City of Lake Elmo Planning Department
Preliminary & Final PUD Plan/Plat

Request: The Northeast Metro Intermediate School District 916 is seeking approval of a preliminary and final plan/plat for Eagle Point Business Park 8th Addition within the Eagle Point Business Park.

To: Ben Gozola, Senior Planner, Sambatek
Cc: Kyle Klatt, Planning Director
From: Jack Griffin, P.E., City Engineer
Re: ISD 916 Intermediate School Building
Final Plat/Construction Plan Review

Sheet Title:
**GRADING AND
EROSION CONTROL
PLAN**

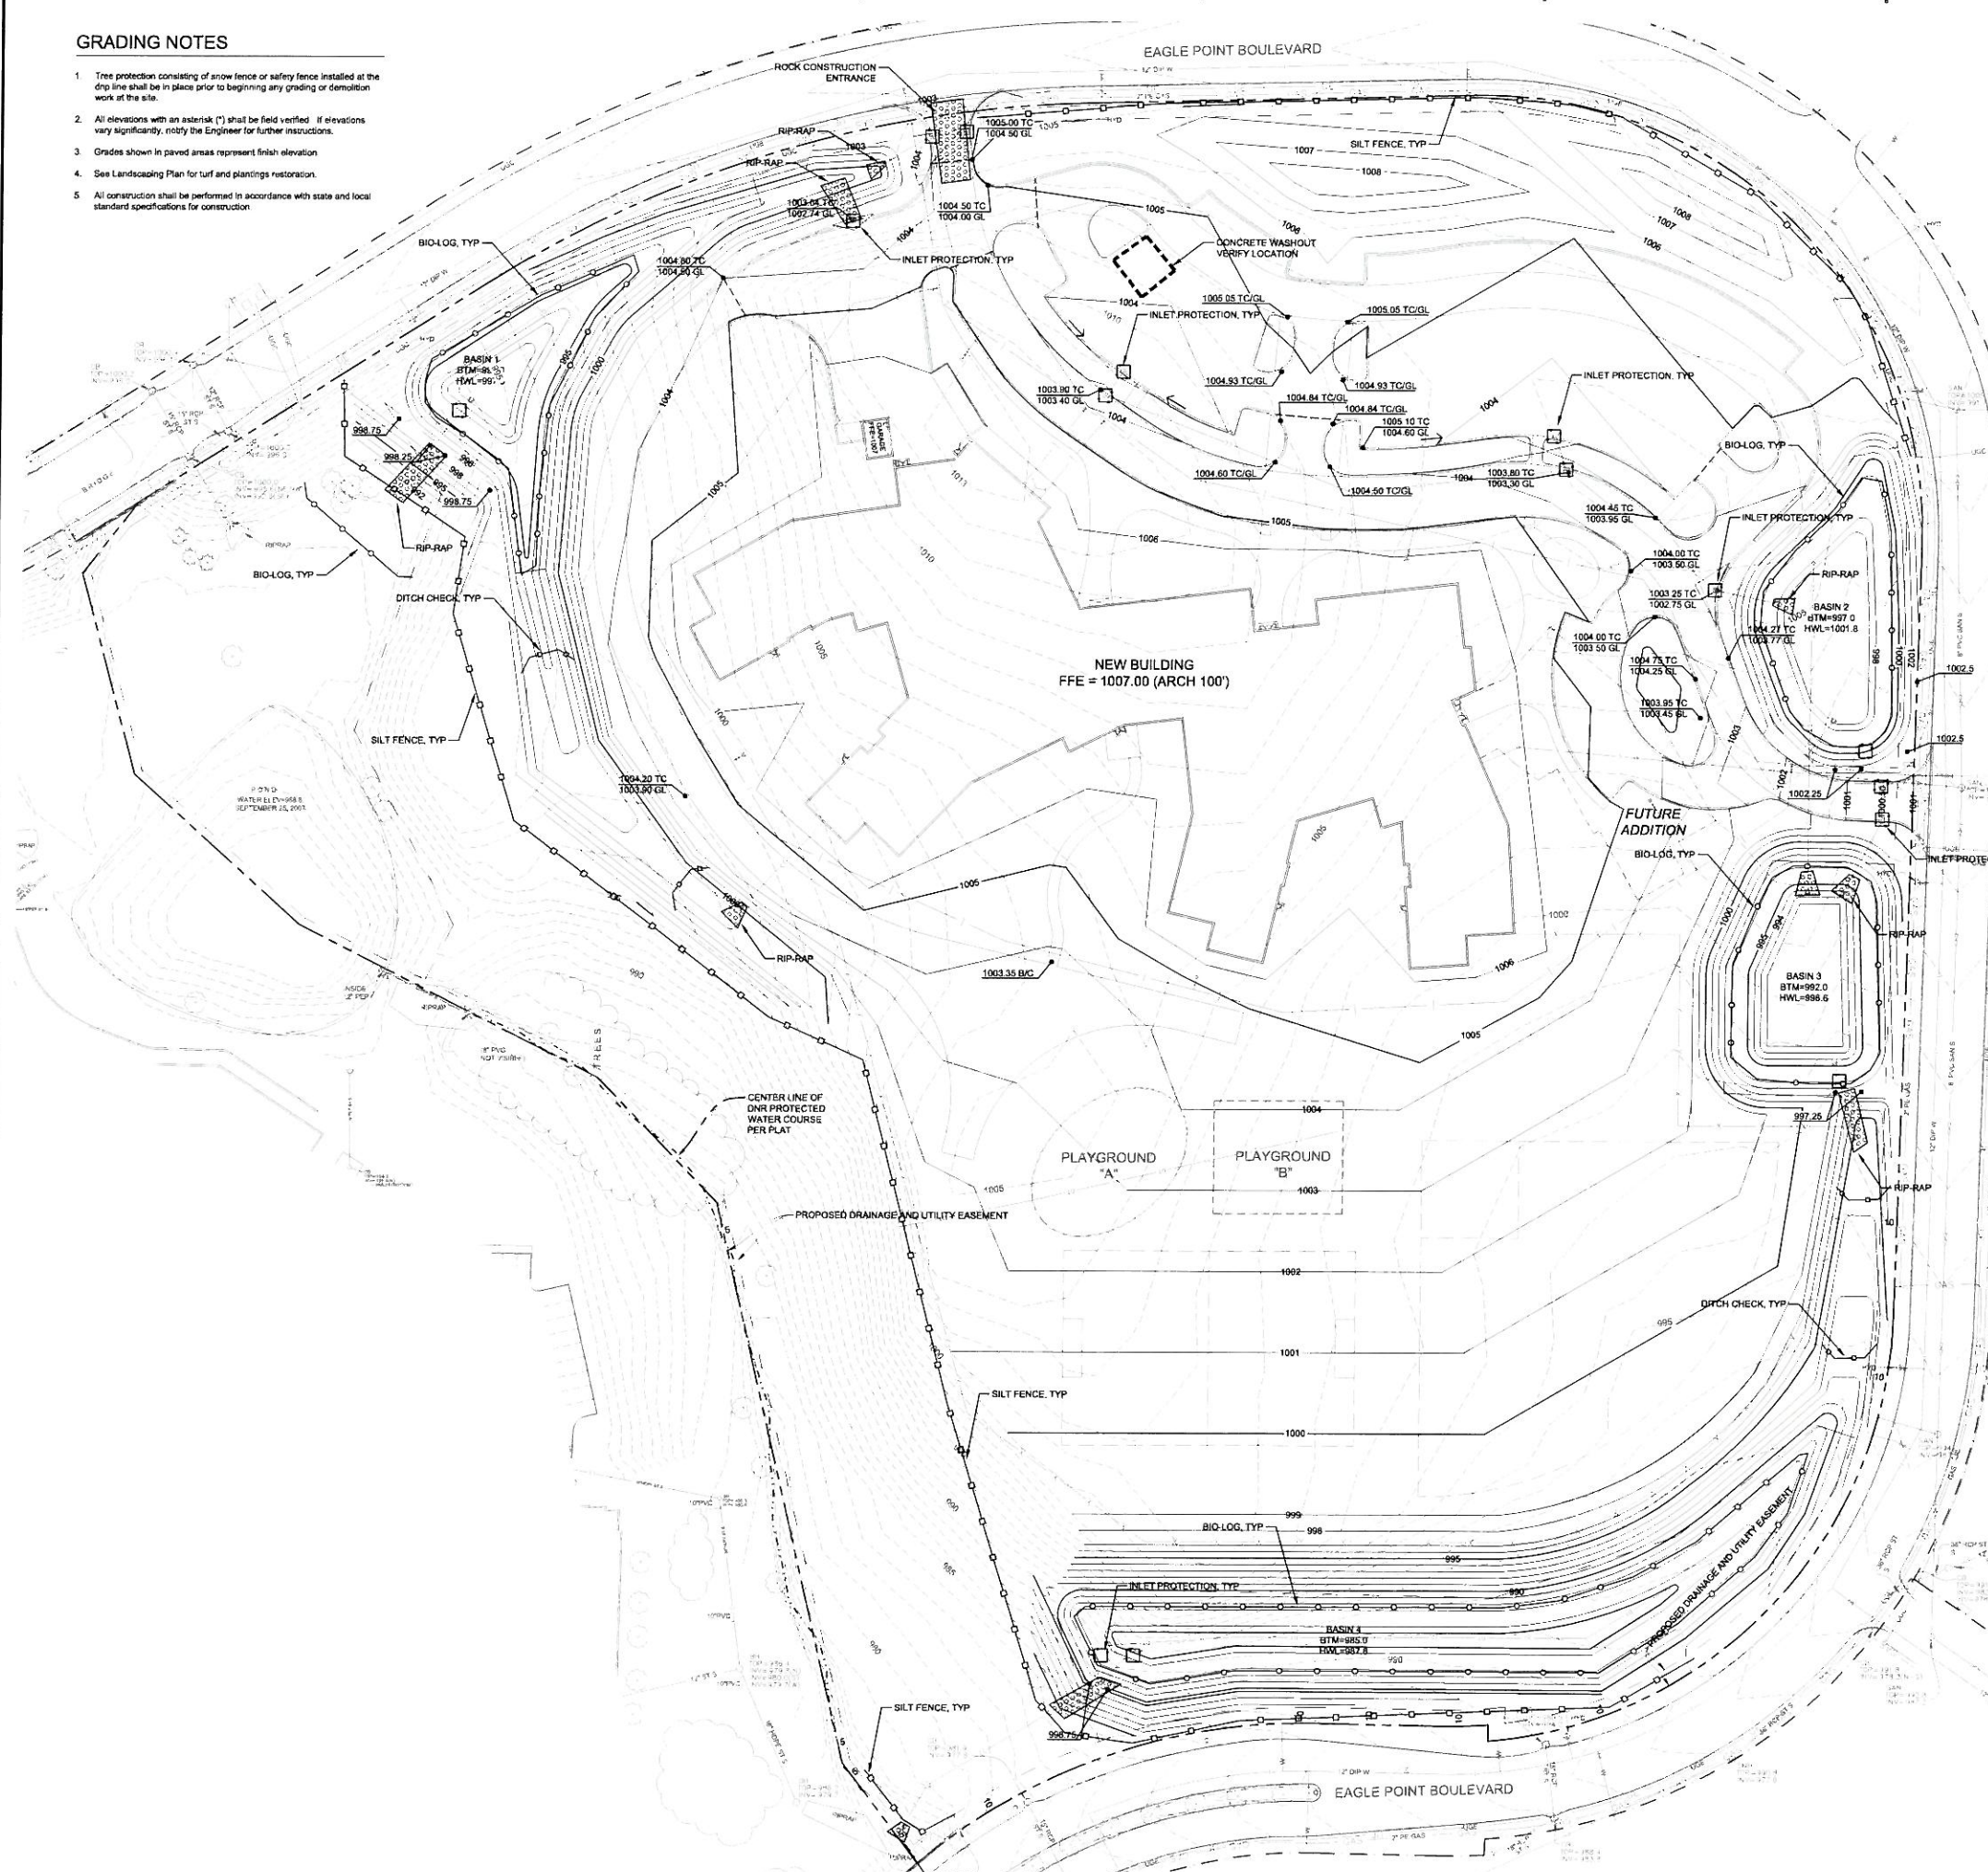
4. Sheet 200CG:
 - City Standard Plan Notes for Grading and Erosion Control must be included on the Grading and Erosion Control Plans. Any plan notes that contradict the City plan notes must be removed.

- A plan note must be added to specify maximum slopes of 4:1 within public R/W.
 - Turf establishment details must be added to the plans. Seed, sod, mulch types and applications must be specified including topsoil requirements and preparation.

- Seeding mixes and turf establishment requirements for infiltration basins must be added to the plans.
 - Plan notes must be added to require the basin subgrade to be scarified to a minimum 12-inch depth prior to the placement of infiltration soil media.

Sheet No. 200.CP

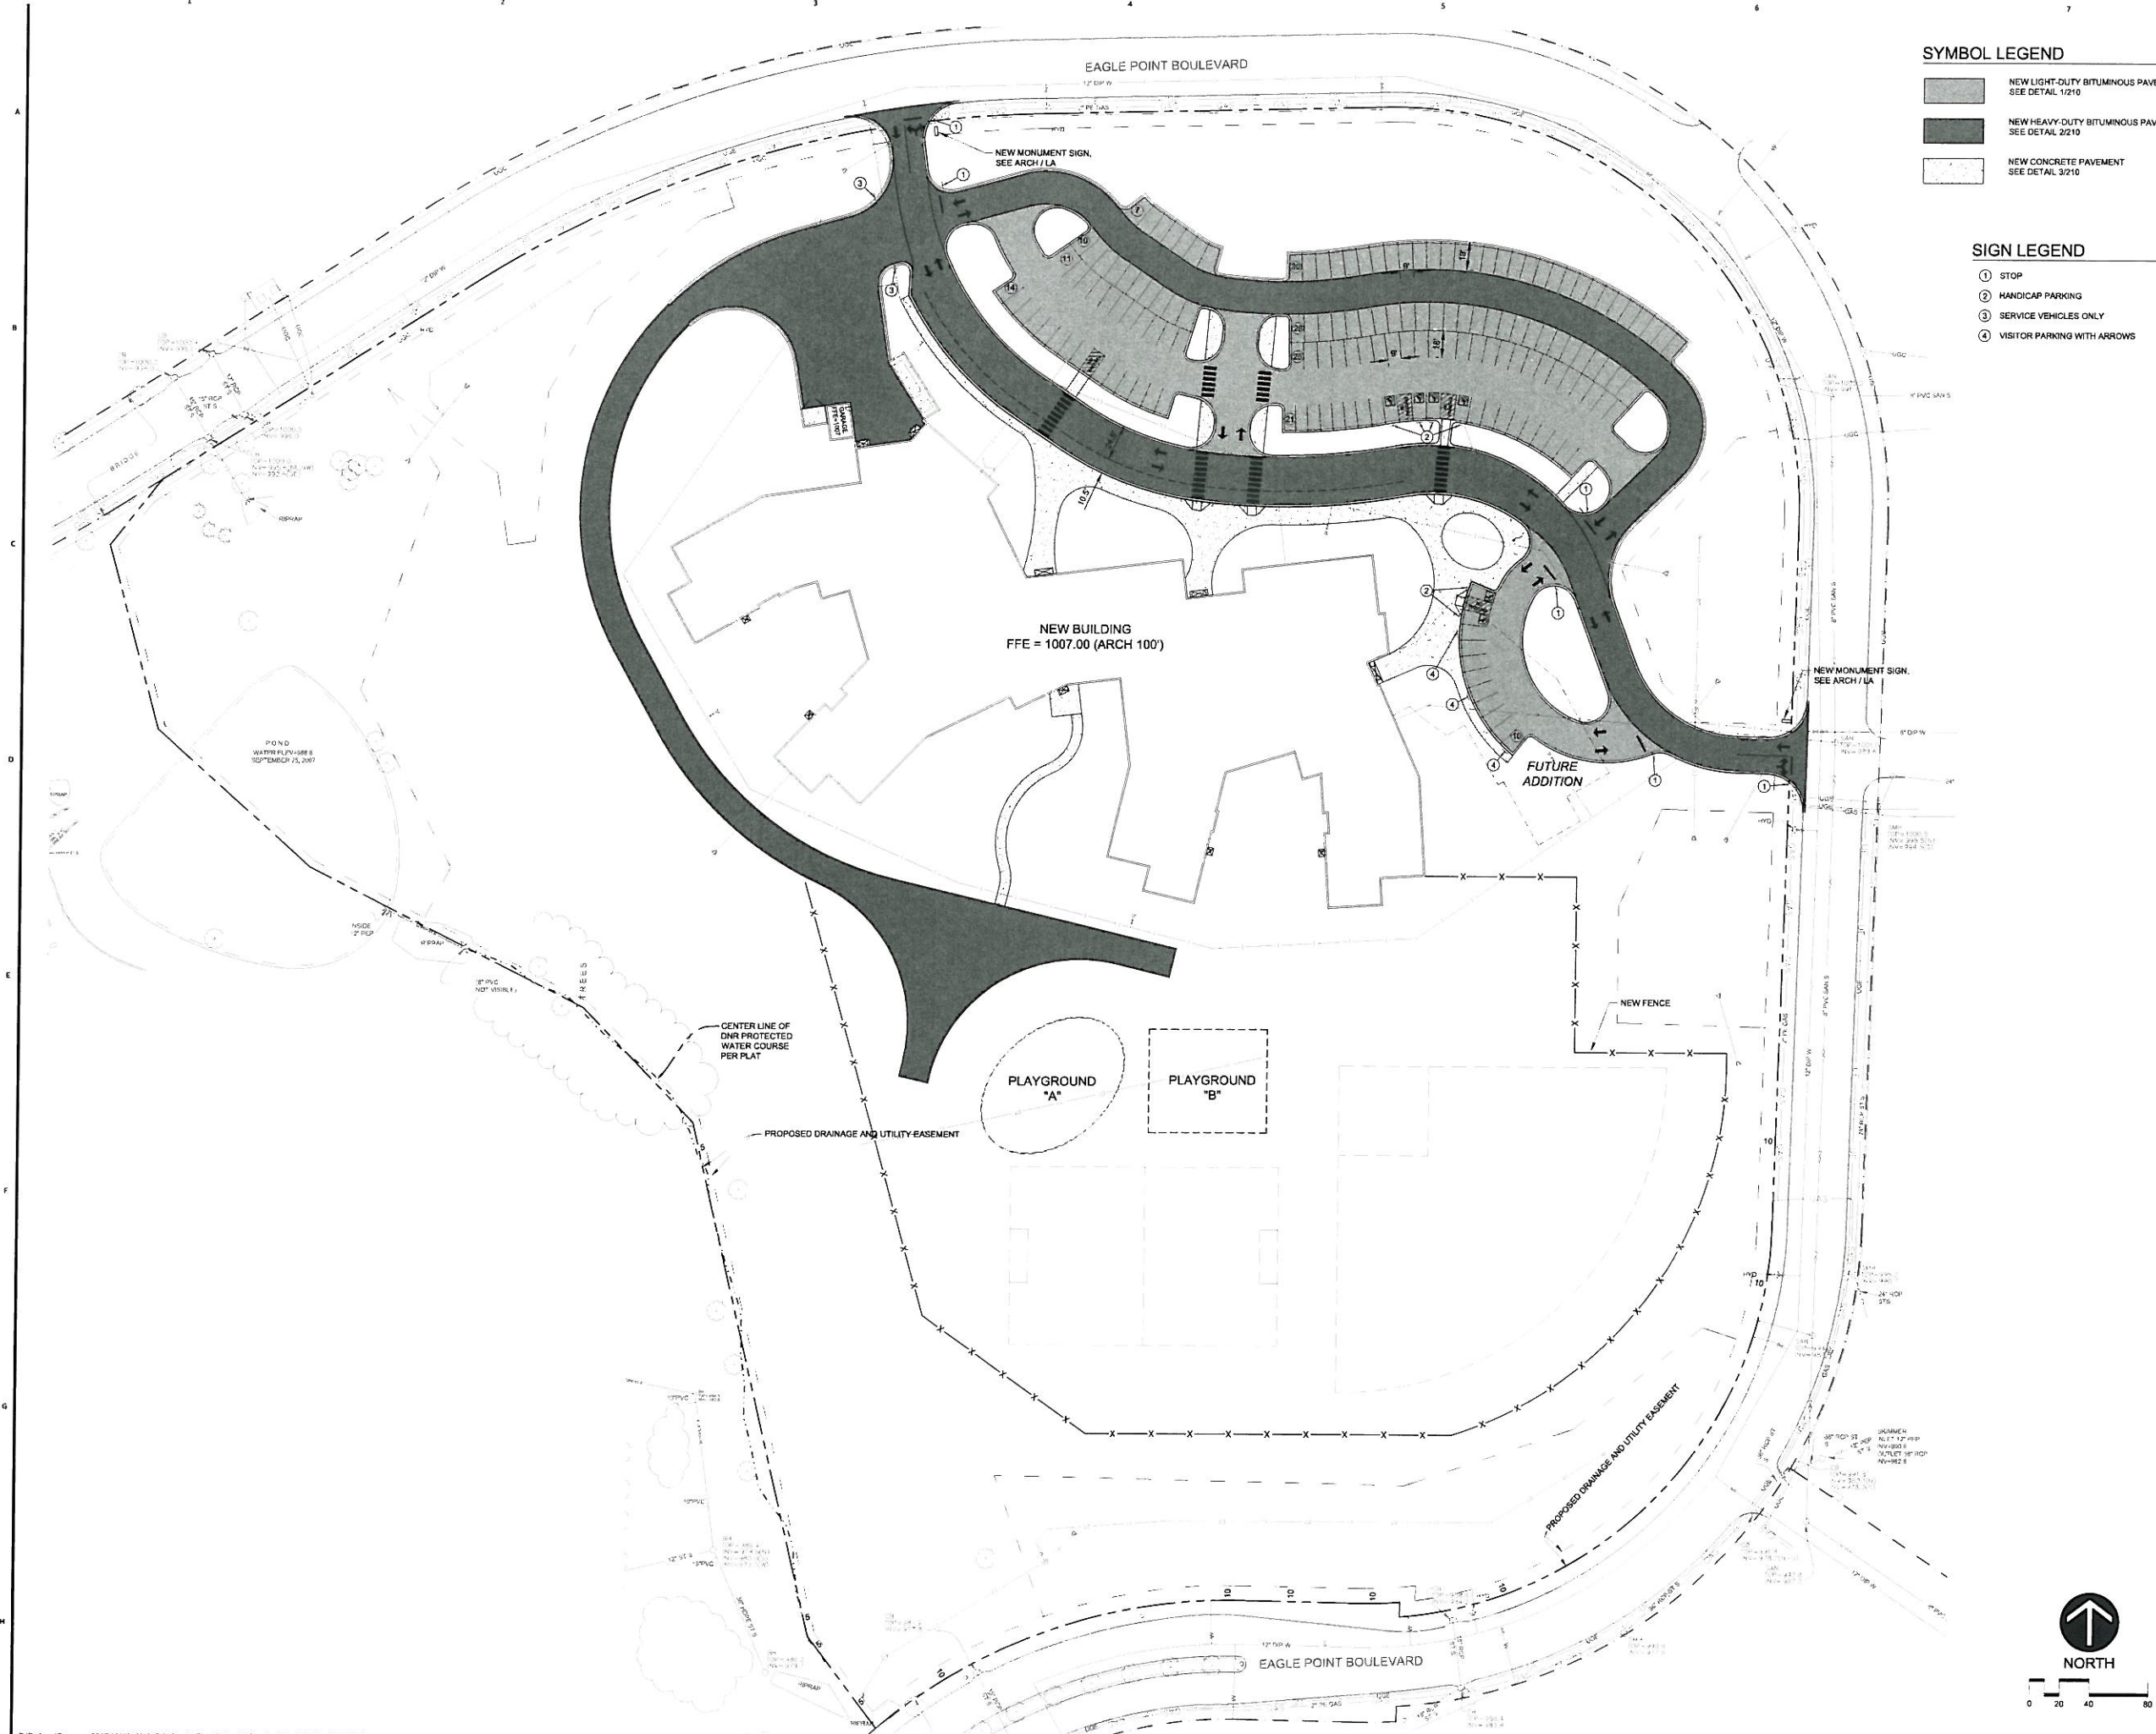
5. Sheet 200 CP:
 - The project proposes two driveway accesses located off Eagle Point Boulevard. It appears that the driveway locations are consistent with staff direction, however the plans must be updated to show the intersection of Island Drive with Eagle Point Boulevard so staff may review and verify access spacing relative to Island Drive.

- Drainage, geometric and profile details must be added to the plans to verify drainage is not directed onto Eagle Point Boulevard at each access driveway. Valley gutters may be required to accommodate drainage along Eagle Point Boulevard.

- Add plan note at each access driveway as follows: "Sawcut and remove existing B618 concrete curb and gutter at the nearest curb joint. Sawcut along existing bituminous street edge must be straight and smooth".

- Fire Protection. Site Plans must be updated to include the placement of Fire Lanes, Yellow painted curbing and No Parking areas for fire protection purposes at the direction of the Fire Chief.
